Ministerial Planning Referral: TPM-2016-5/B
685-691 La Trobe Street, Docklands

15 June 2021

PLANNING REPORT

Application number:	TPM-2016-5/B
DTPLI Application number:	PA1500055-2
Applicant / Owner / Architect:	Urbis / Perpetual Corporate Trust Limited / Cox Architecture
Address:	685-691 La Trobe Street, DOCKLANDS VIC 3008
Proposal:	Amend the existing Planning Permit PA1500055 for the site to facilitate the development of a two tower Build-to-Rent residential scheme, including a three level podium, including a large function space.
Cost of works:	Cost of works increased by \$40,000,000. Total cost \$230,000,000
Date received by City of Melbourne:	11 December 2020 RFI received 26 February 2021
Responsible officer:	Matthew Metaxas
Report Date:	24 May 2021
(DM# 14601688)

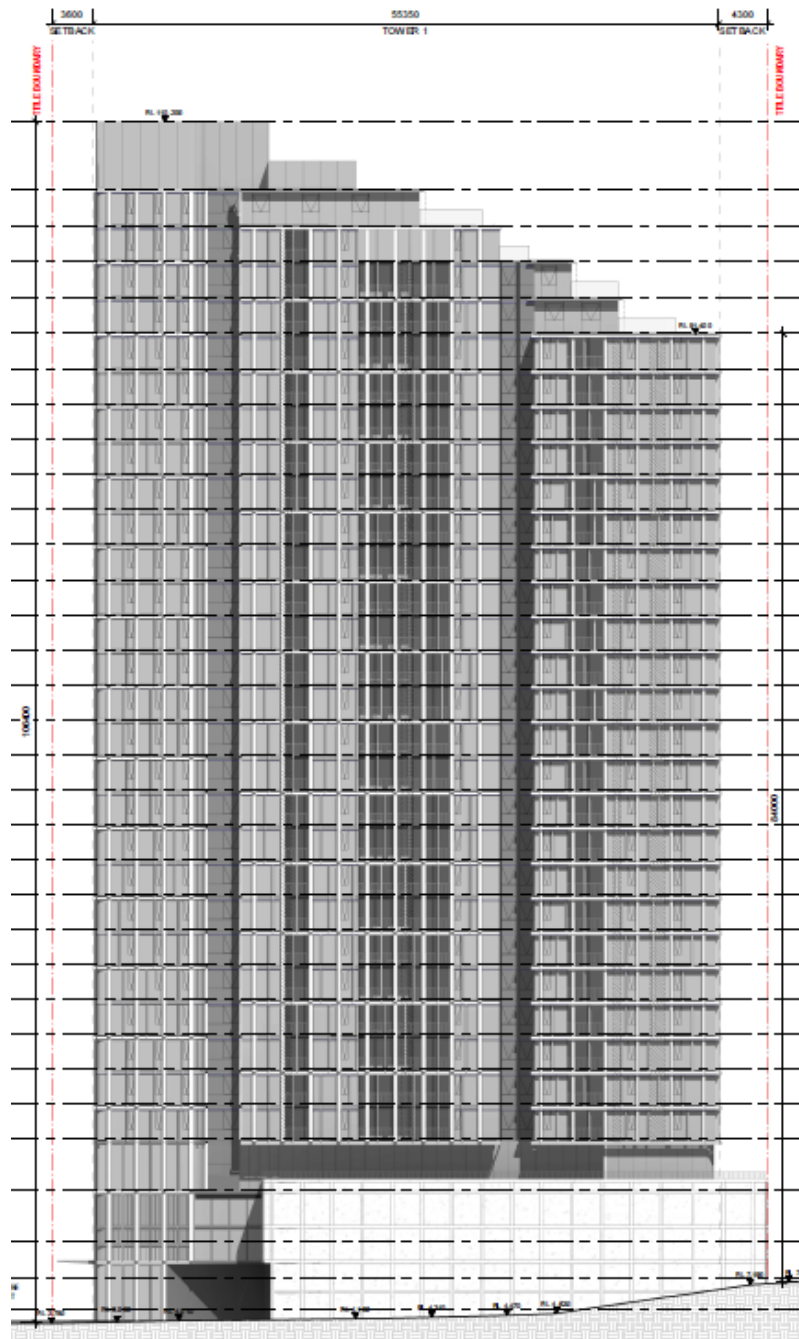
DDO52 sets broad parameters for built form in the northern portion of the Stadium Precinct (Area 1 & 2).

Area 1 (western half of the site) anticipated at least two towers with a maximum height of 75m above a podium of 25m while Area 2 (eastern half of the site) anticipated one tower with a maximum height of 75m above a podium of 25m.

When considered against the Decision Guidelines, the proposal is in keeping with the objectives of the DDO, as the built form at the overall height of 100.2 metres (excluding roof plant) sits reasonably within other approvals above the discretionary

Shadowing

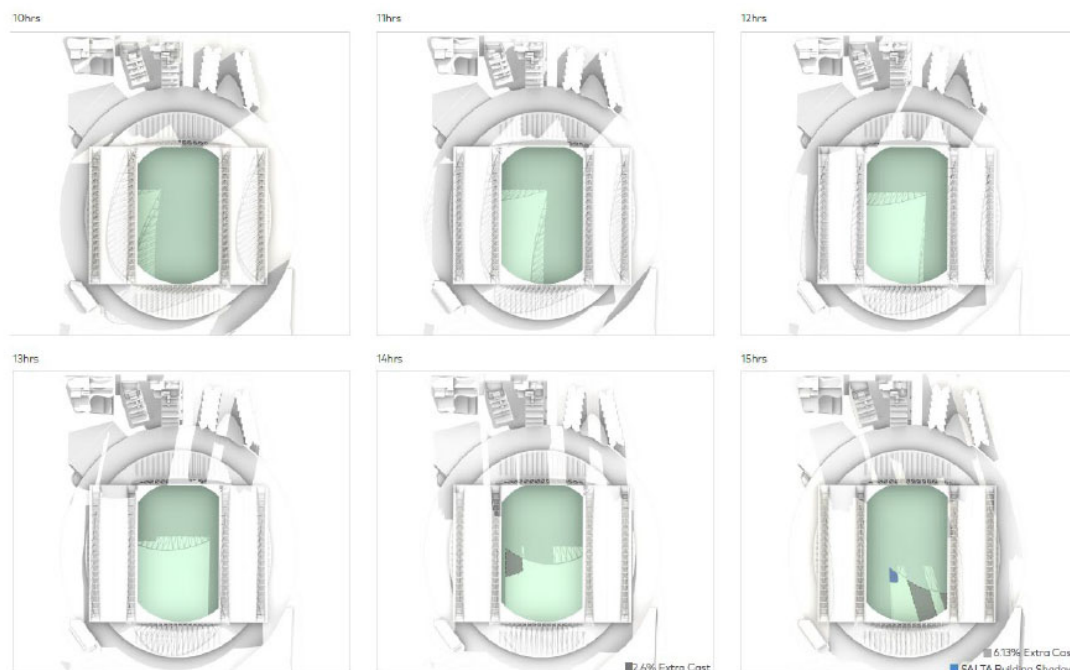
DDO52 also requires consideration of the impact of overshadowing on the playing field of the Stadium, to ensure that the playing field is not detrimentally overshadowed by the surrounding development which seeks to ensure that the grass quality can be maintained by means of natural light. Since the Stadium was originally developed, grow lamps are now used as the primary mechanism in which to cultivate the playing surface without natural sunlight, therefore the requirement for natural light is no longer as critical as previously. Notwithstanding this, the overshadowing of the playing surface cannot result in an instance where the overshadowing from surrounding developments no longer affords the stadium sufficient daylight to rely on natural light rather than the artificial lighting systems currently employed for the playing field which should remain an option for the Stadium operator.

The Shadow Study Analysis (see below) demonstrates the potential overshadowing projected to the stadium's playing surface by the revised scheme. The Shadow Study indicates there is no overshadowing on to the playing surface to midday, while at 1pm the overshadowing of the proposal remains within the stadium's own overshadowing from the trusses of the stadium roof overshadowing the field. However, from 2pm onwards the shadowing of the proposal does impact on the Stadium field.

The increased shadowing from the revised design scheme is limited and is not considered to negatively impact the Docklands Stadium playing surface due to the artificial lighting systems employed by the stadium.
